REMARKS

Amendments to the Drawings:

FIG. 2 (PRIOR ART)

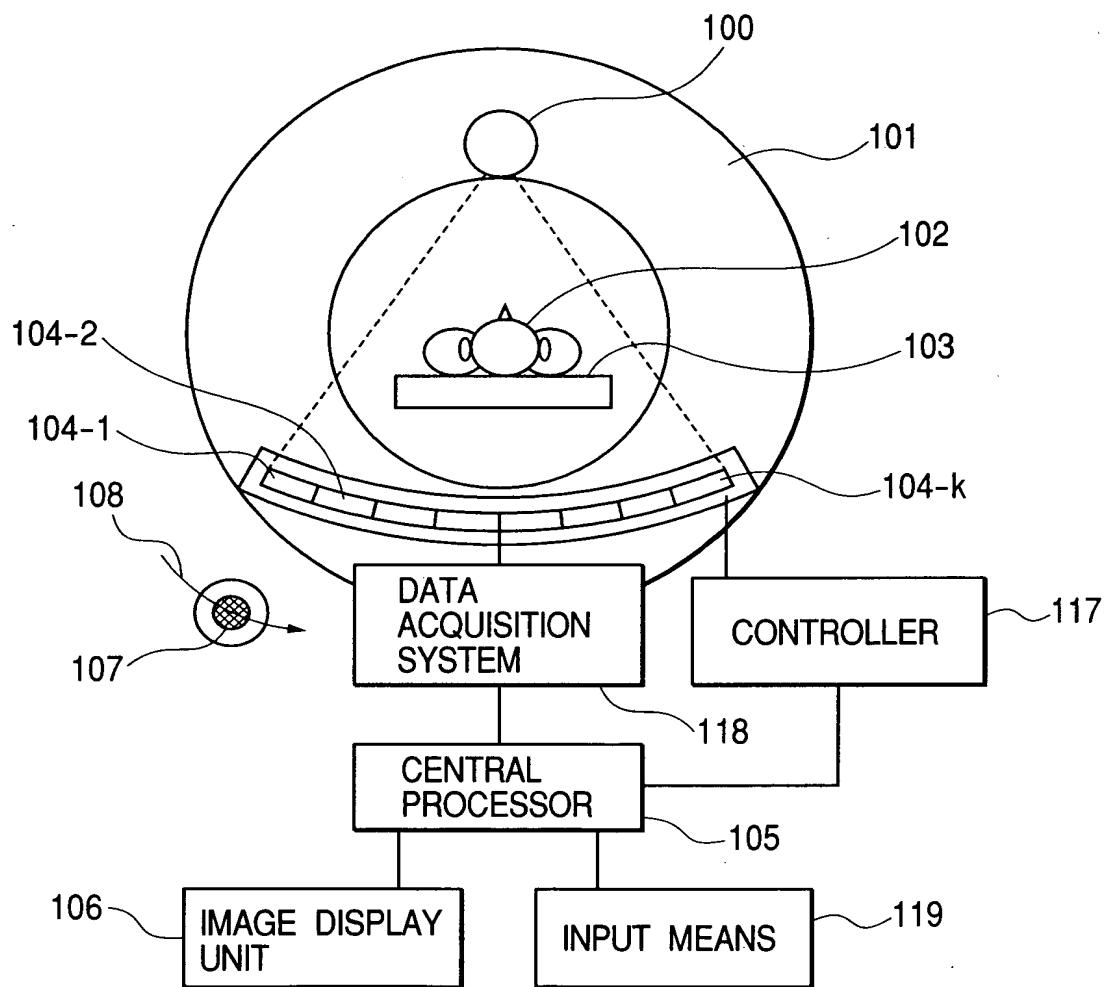
With respect to the objection to the drawings, submitted herewith are replacement drawings in which Figures 2 and 3 have been labeled as "Prior Art" such that the objection to the drawings should now be overcome. Accordingly, acceptance of the drawings is requested.

The attached sheets of drawings include changes to Figs. 2 and 3. These sheets, which include Figs. 2 and 3, replace the original sheets including Figs. 2 and 3. These figures have been amended to include the legend "Prior Art".

SKETCH

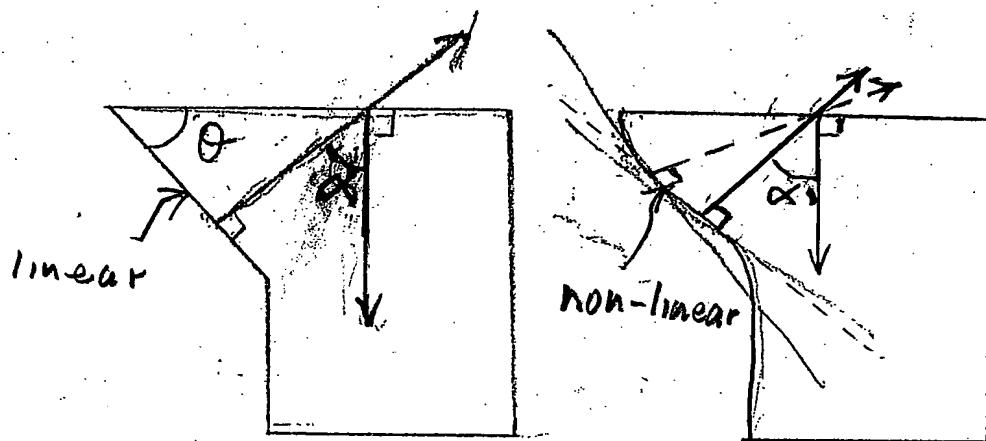
Applicants note that by the present amendment, a new dependent claim 11 corresponding somewhat to the features as previously recited in claim 2 has been presented. Reference is made to the attached sketch, corresponding to a portion of Figures 7 and 15, respectively, showing a different angular relation which corresponds generally to the angle θ of Fig. 7 wherein an angle is defined as being between a vector extending from a surface adjacent the light input surface and a vector extending from the light input surface, generally indicated as the angle α in the attached sketch and having a relationship that the angle is at least 45° and not greater than 90° . Thus, applicants submit that claim 11, as presented, recites features corresponding to that of claim 2 and dependent claims 12 and 13 recite the adjacent surface as being a linear surface or a non-linear surface, as shown in the attached sketch. As is apparent, such claims further patentably distinguish over the cited art and should be considered allowable.
